Subject: Response to LRA Request for Additional Information (RAI)
R. E. Ginna Nuclear Power Plant
Docket No. 50-244

R. E. GINNA
LICENSE RENEWAL APPLICATION
REQUEST FOR ADDITIONAL INFORMATION

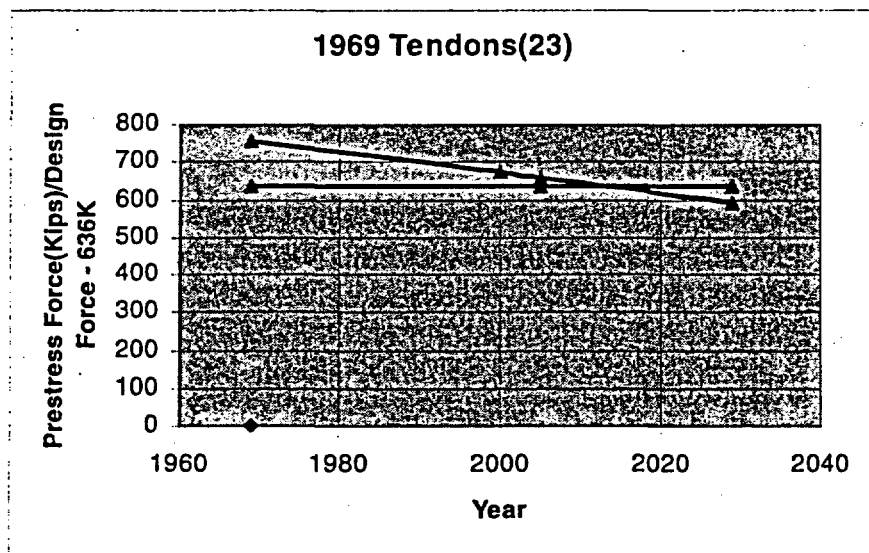
In order for the staff understand the quantitative aspect of the analysis, the applicant is requested to provide the following information:

- b) The applicant is requested to provide the same information for the remaining 137 tendons, for the inspections performed after 1980 retensioning.
- c) In the operating experience element of Section B3.3 of the LRA, it indicates that 23 tendons out of 160 tendons were retensioned 1000 hours after initial prestressing. It is not clear if the 23 tendons retensioned after initial prestressing were parts of the randomly selected tendons in the subsequent surveillance of tendons performed as per Regulatory Guide 1.35, or IWL-2520. The applicant is requested to provide information regarding the trending of prestressing forces in these 23 tendons.

a) Based on the available test information for this set of 23 tendons that were retensioned in 1969, the below graph shows the trend line from 1969 projected through 2005, and out to 2029. The graph also includes a constant line at 636 kips, which is the minimum design prestress force.

b) Based on the available test information for this set of 137 tendons that were retensioned in 1980, the below graph shows the trend line from 1980 projected through 2005, and out to 2029. The graph also includes a constant line at 636 kips, which is the minimum design prestress force.
